UNITED STATES
NUCLEAR REGULATORY COMMISSION
WASHINGTON, D. C. 20555

SUBJECT: DIFFERING PROFESSIONAL VIEW (DPV) CONCERNING CONTAINMENT
ISOLATION VALVES AT ZION

AN EVALUATION OF THE CRITERIA FOR
AND
THE CALCULATION OF OFFSITE DOSES DERIVING FROM
OPEN CONTAINMENT PURGE VALVES DURING
A LOCA AT ZION UNITS 1 & 2

DATED JULY 20, 1989

ZION 1 & 2 CONTAINMENT INVENTORIES DURING LOCA BLOW DOWN

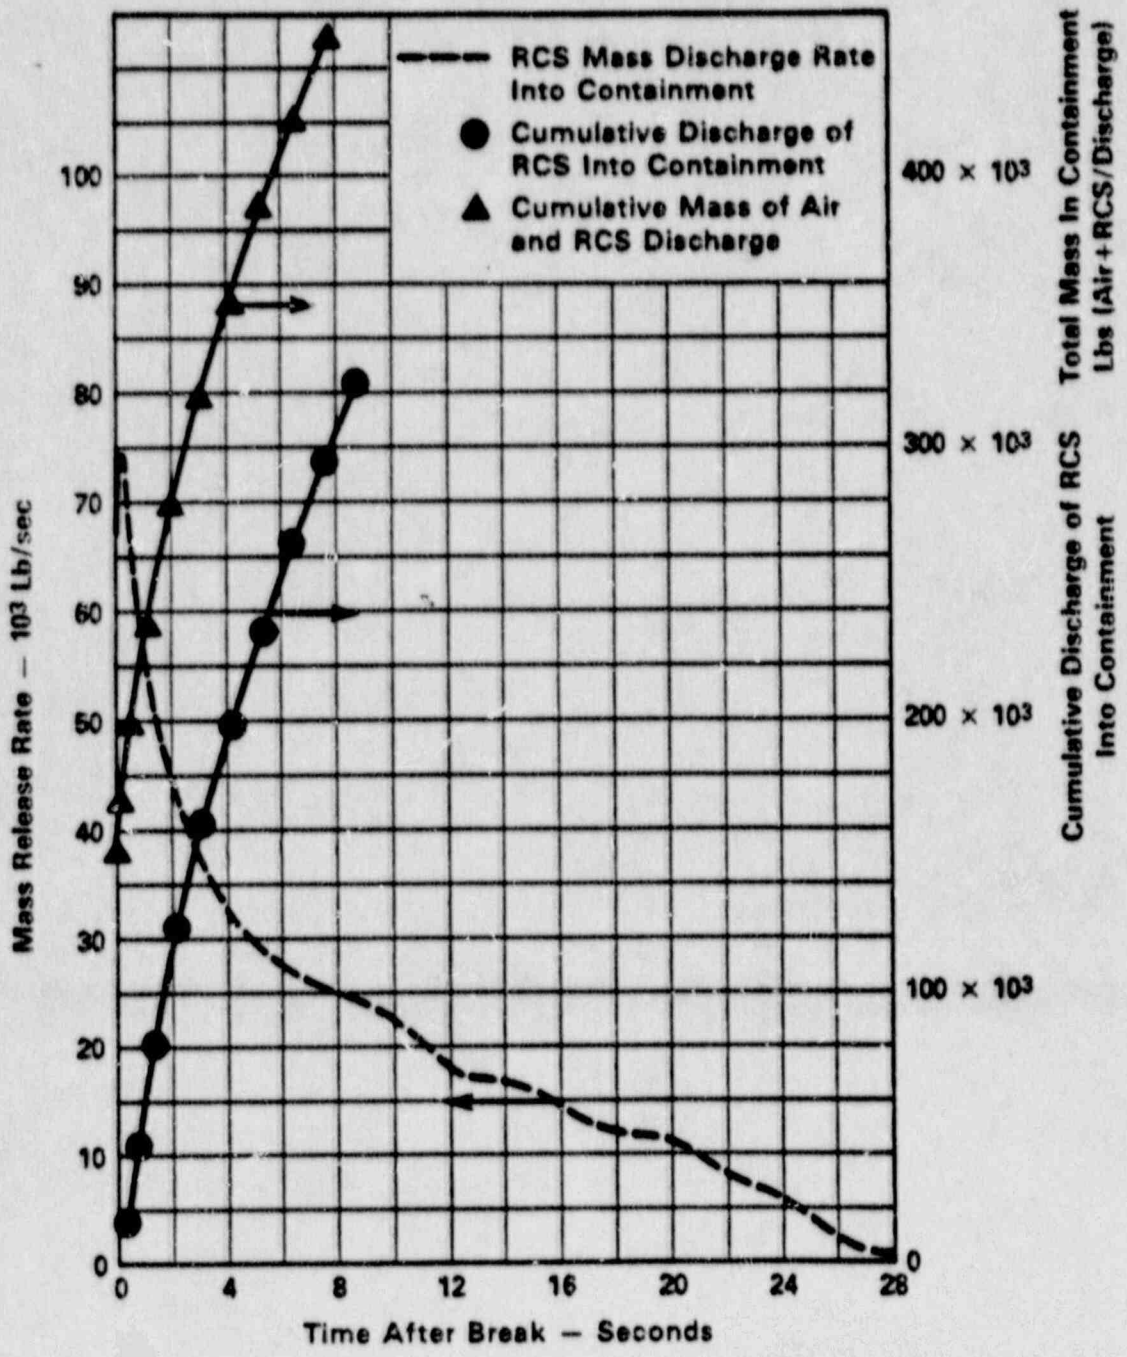
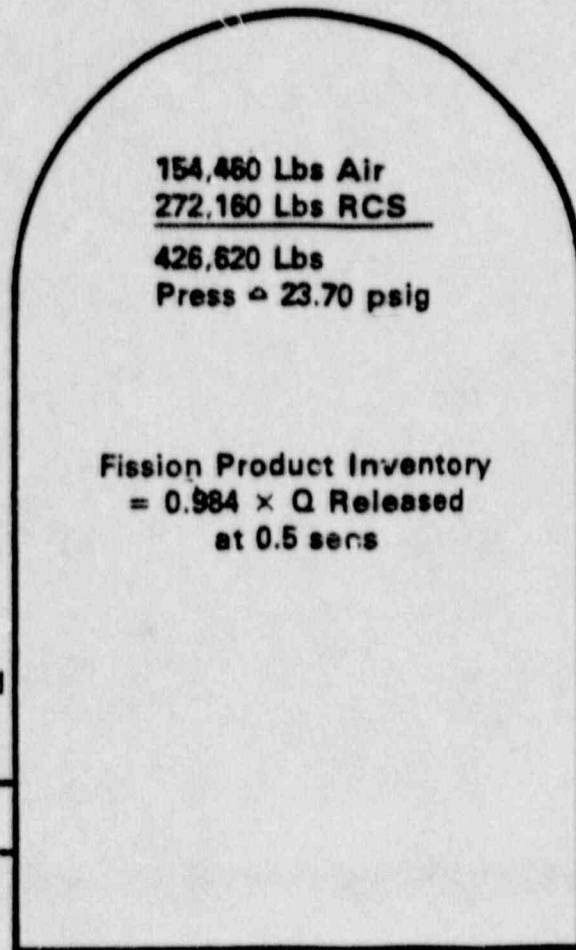
Containment volume of 2 million cubic feet originally containing 144,000 lbs of air reduces fission product discharged from the RCS by prior dilution through mixing. Exhibits 3 and 4, and 3A and 4A show the circumstances for containment and the discharging reactor coolant system.

If it is assumed that all fission product released from the core is immediately available to containment as in RG 1.4, then total mixing of this product should be assumed to occur on initiation of the LOCA. (The data presented show the results for a release $\frac{1}{2}$ second after the LOCA, but the differences are not significant for the intent of this submittal.) As a result, containment inventory discharged contains a uniform concentration of a decreasing curie content over the first 7 seconds, and the net result is a release to outside containment of 4.38% of the source term fission product inventory Q, released from the core on occurrence of the LOCA. (A reduced amount of 1.57% is released for partly closed valves). Exhibit 2A shows that for the RG 1.4 source term, this gives a total release from containment over the first 7 seconds of 1.7×10^6 curies direct to atmosphere. Related offsite dose is 490,000 rem for 2 x fully open valves. Partially open valves reduce this to the value shown in Exhibit 2 of 612,000 curies and 156,000 rem.

Figure 14 F.2-19a Peak Clad Temperature - DECLG (C_D=1.0)
(Unit 1)

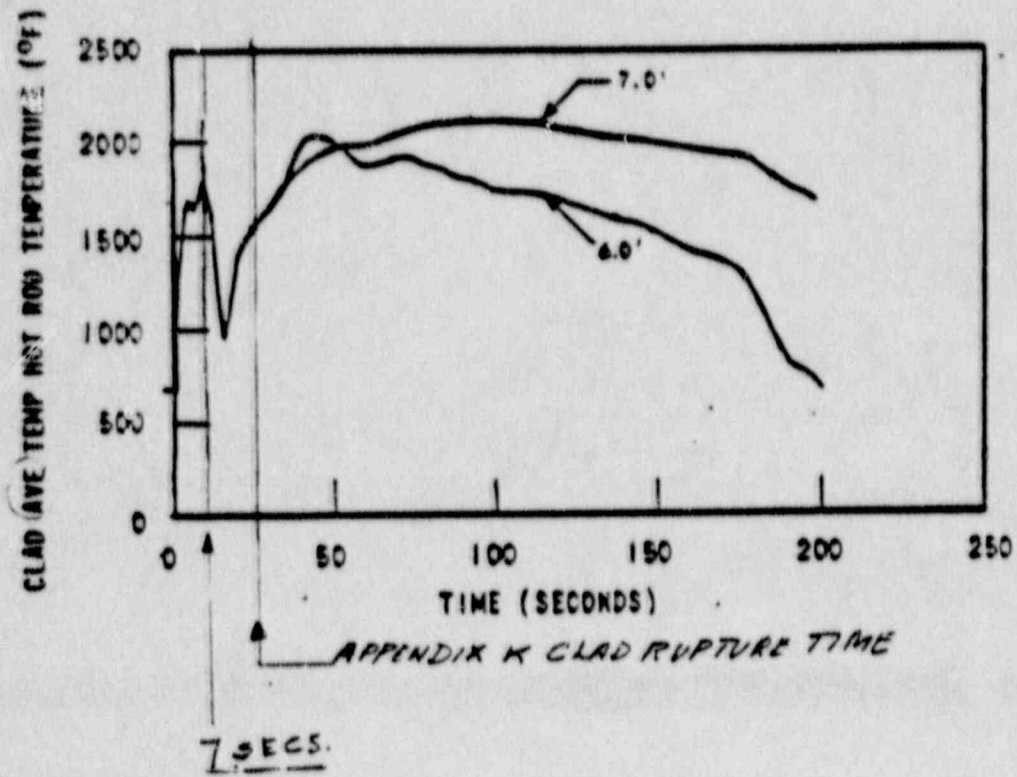
Exhibit 6 shows the average clad temperatures deriving from Appendix K calculations from the Zion FSAR, Figure 14 F. 2-19a, (Ref. 33). This shows that on infringement of DNBR at 1/10 second, average clad temperature increases very rapidly from a normal operating value of 720°F to at least 1350°F, and then to 1750°F, over a total period of seven seconds; thereafter temperature reduces rapidly to 1000°F at about 15 secs. from which it sharply increases ultimately to approx 2200°F.
